DART+ West

OPTION SELECTION REPORT

ASHTOWN REVISED PREFERRED OPTION REPORT

March 2022

Figure 4-5 Ashtown Option 2 Under Rail and Canal (Copyright Ordnance Survey Ireland – 0039720)

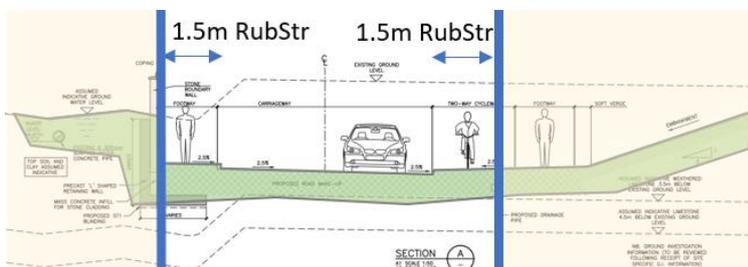
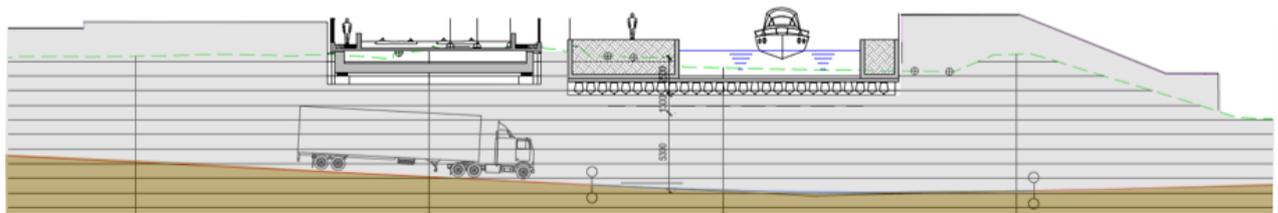
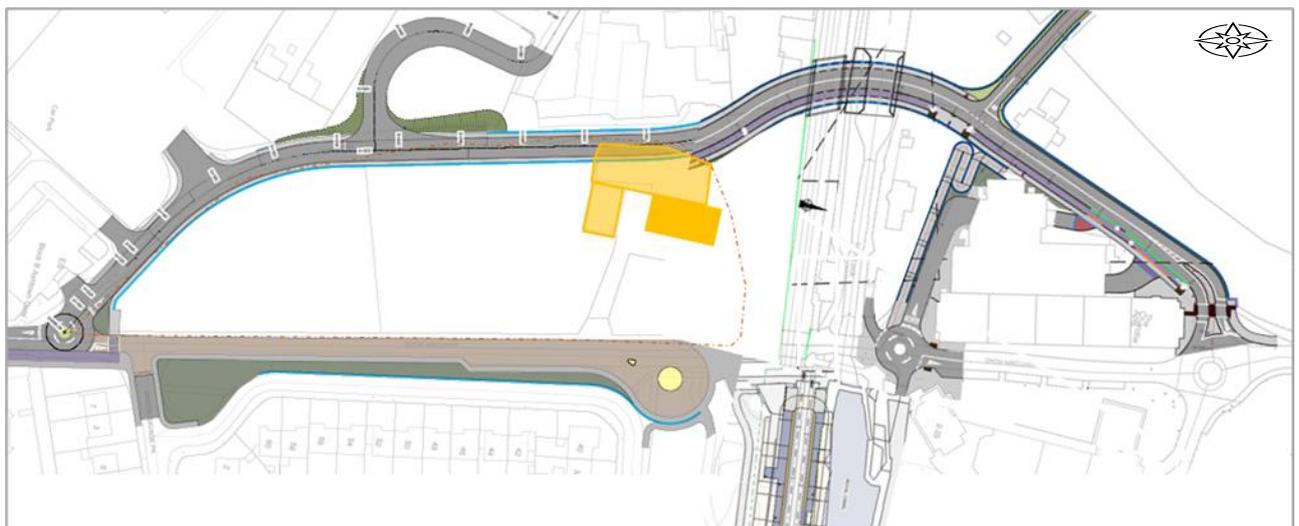
The revised option is illustrated in **Figure 4-5** below. It also includes a long section characterising the proposed canal and railway underbridges. A section has been provided to illustrate the original proposed cross section in comparison to the proposed narrower cross section.

Figure 4-12 Ashtown Option 8 – Provision of a Pedestrian/Cycle Overbridge (Copyright Ordnance Survey Ireland – 0039720)

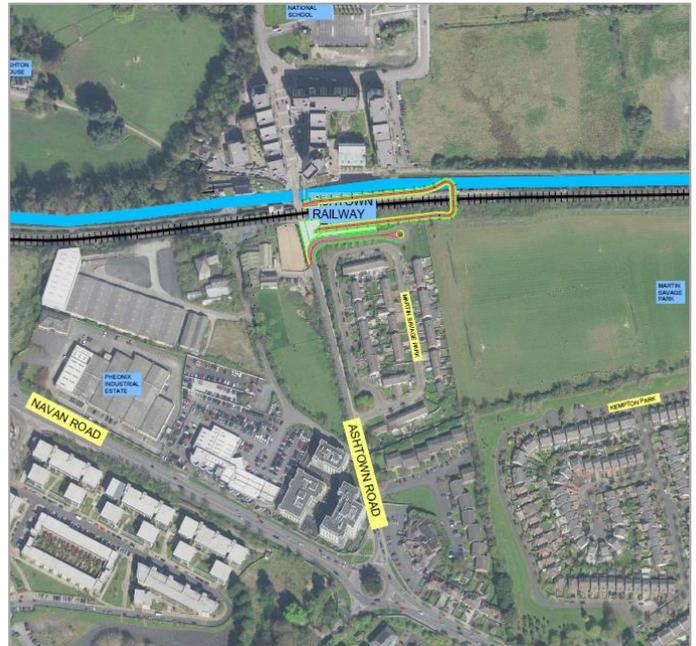
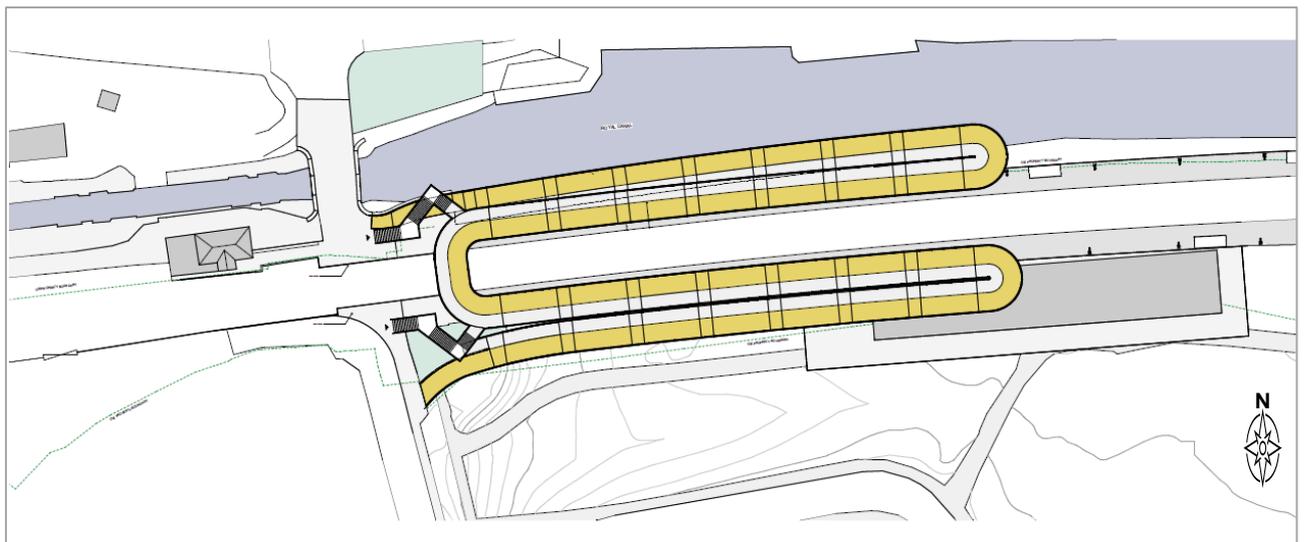
As part of the review it is proposed to alter this option by inclusion of the proposed pedestrian cycle bridge and reconfigured train station as described in **Section 4.2.1** and illustrated in **Figure 4-12**. No measures are proposed as part of this option to accommodate diverted traffic on the local road network.

Figure 4-14 Ashtown Option 10 Under Rail and Canal

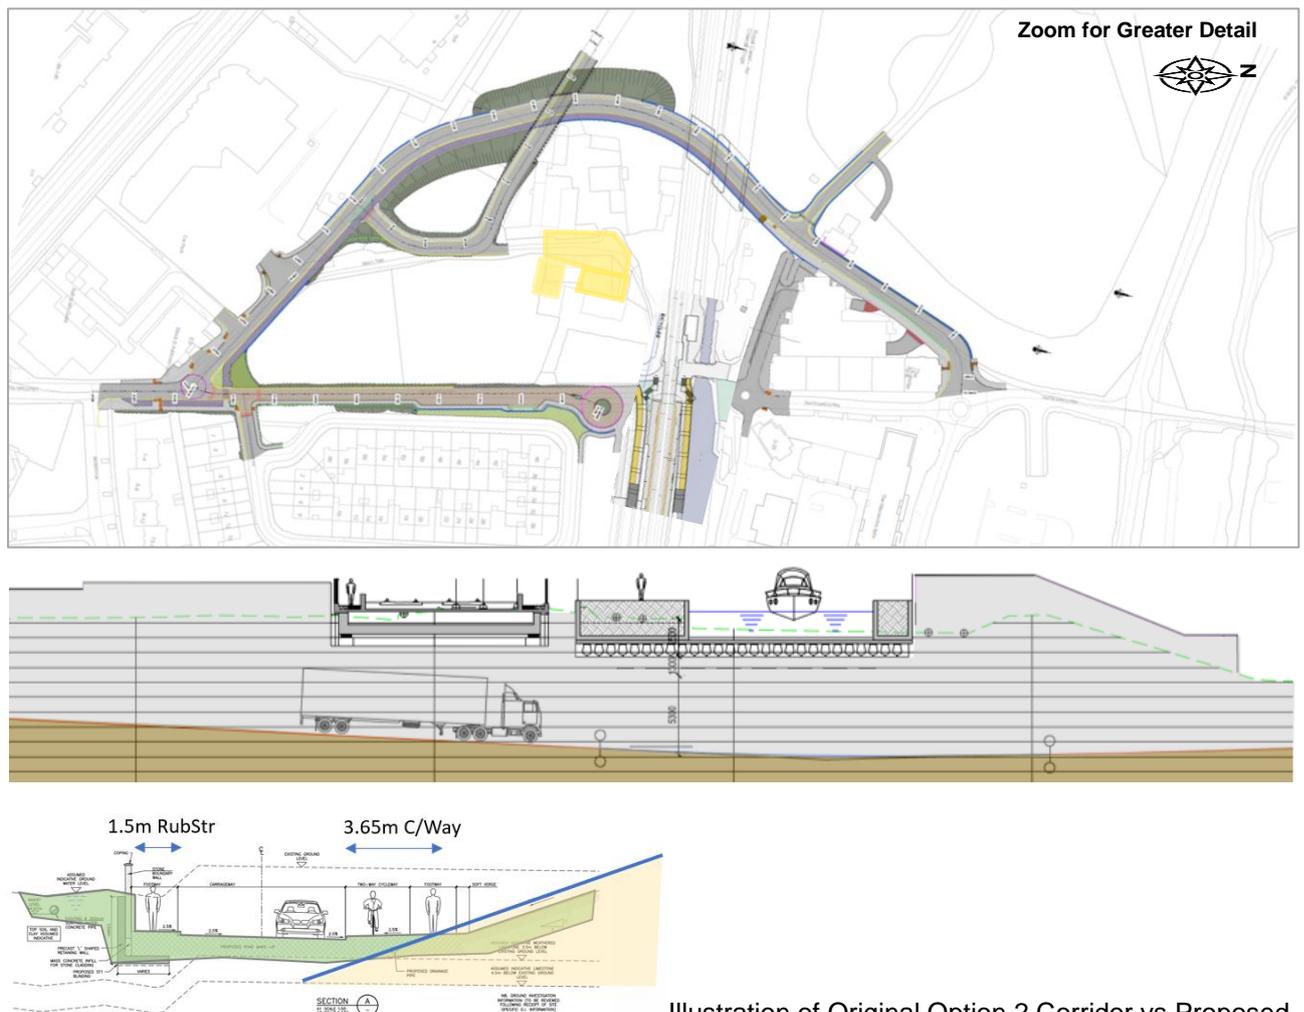
The length of the option is approximately 170 m on the northern side and 300 m south of the rail line. The option would drop to an approximate level of 37.5 m ODMH under the railway which is at a level of 45.6 m ODMH at the bridging point. On both sides of the railway a separate pedestrian and cycle link is proposed to provide enhanced access for non-motorised users. These shared spaces would have a width of 3.0 m.

It is feasible to cross at this location, as it is upstream of the double lock on the canal and the canal is at the same approximate level as the adjacent railway. This option would require some property acquisition and modifications to existing accesses. This option also proposes the inclusion of the enhanced non-motorised access at the reconfigured train station as described in **Section 4.2.1**.
